FirstEnergy Nuclear Operating Company

Docket Number 50-346

Subject: Request for Additional Information Regarding the 2002 Steam Generator Tube
Inspections (TAC No. MB9541)

Request for Additional Information
Davis-Besse Nuclear Power Station 2002 Steam Generator Inspection
TAC No. MB9541

Axial Partial Throughwall OD Crack at 4050 psi

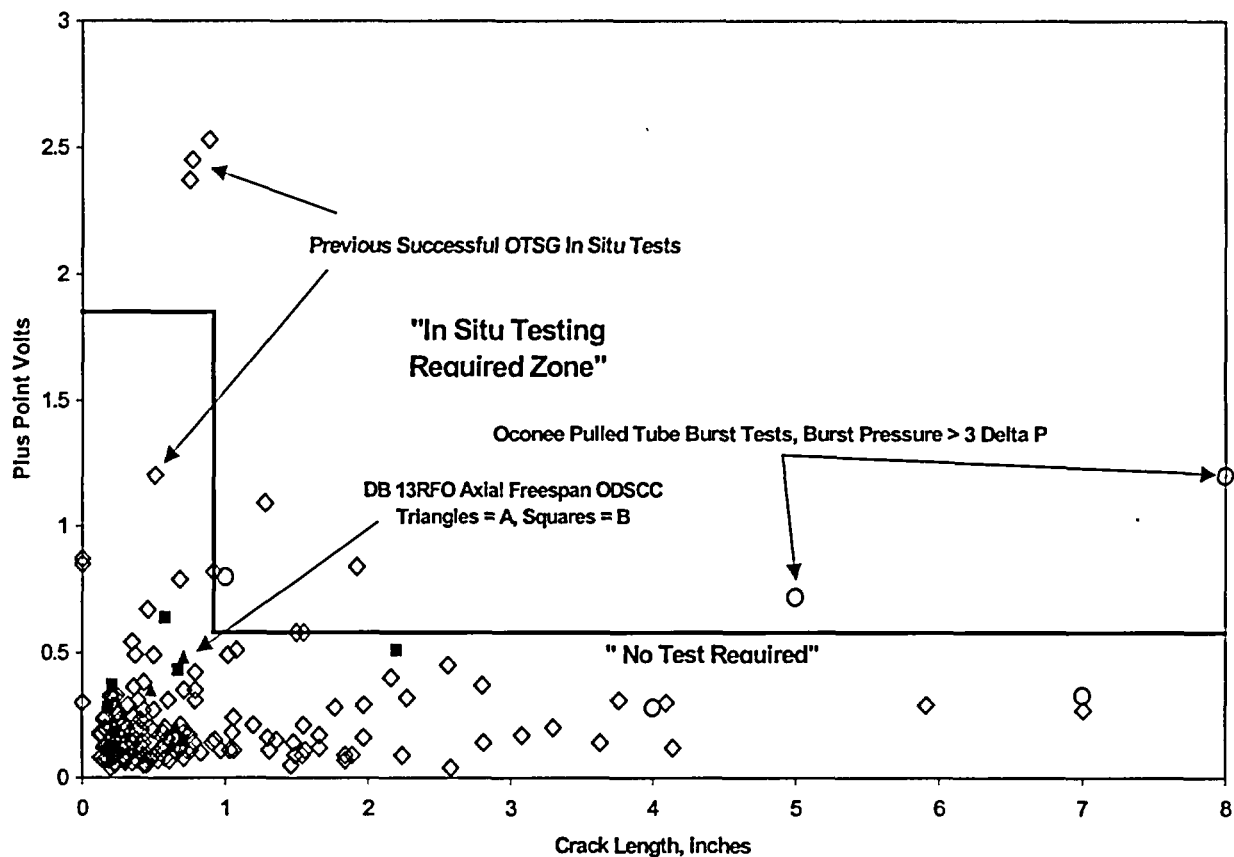
2. *During a pre-inspection conference call between Nuclear Regulatory Commission (NRC) and Davis-Besse staff (refer to ML021410043), it was indicated that Davis-Besse would perform in-situ pressure testing of the tube in row 22, tube 93, in SG 2A. Discuss the criteria you used to determine which indications were in-situ pressure tested and the results of all in-situ pressure tests performed during the outage.*

The plus point depths recorded in the indication list is a flaw maximum depth whereas the condition monitoring curves for in-situ screening are based on structural controlling depth which has been demonstrated to be approximately 0.8 times the maximum flaw depth. The following curve is from the in-situ selection criteria for partial wall penetration axial flaws. For ODIGA/SCC, the worst depth standard error of 25 % was used.

Plus point voltage screening was also used as a consideration for the in-situ selection based on historical in-situ and pulled tube burst results. The graph below compares plus point voltages and lengths of the freespan axial ODSCC degradation observed at the DBNPS with a database of previous successful in-situ tests for this type of degradation in other OTSG plants. By this measure it is seen that the severity of degradation at the DBNPS did not pose a threat to structural or leakage integrity. As a conservative measure, in-situ tests to the 3 delta-P limit with allowances for temperature differences and pressure gauge uncertainty were performed for 4 freespan axial ODSCC indications.

Voltage Distribution for Dents
DBNPS SG 2-A 02/02 13RFO

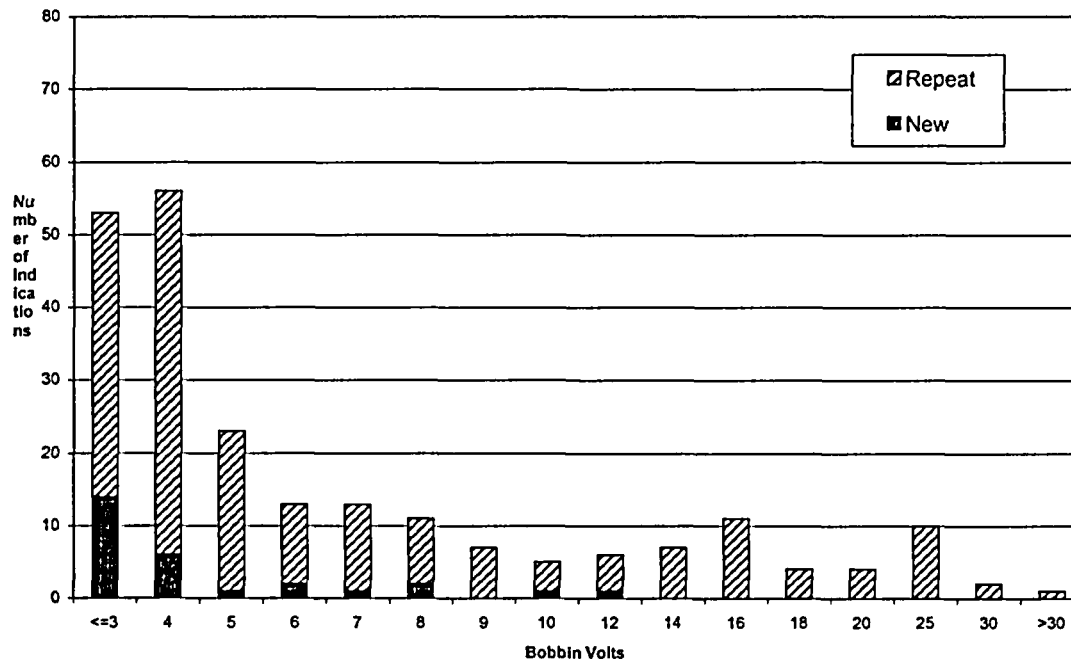
b. *The number, location, and severity of your dents/dings.*

The voltage distribution for dents during 13RFO was as indicated on the attached figures:
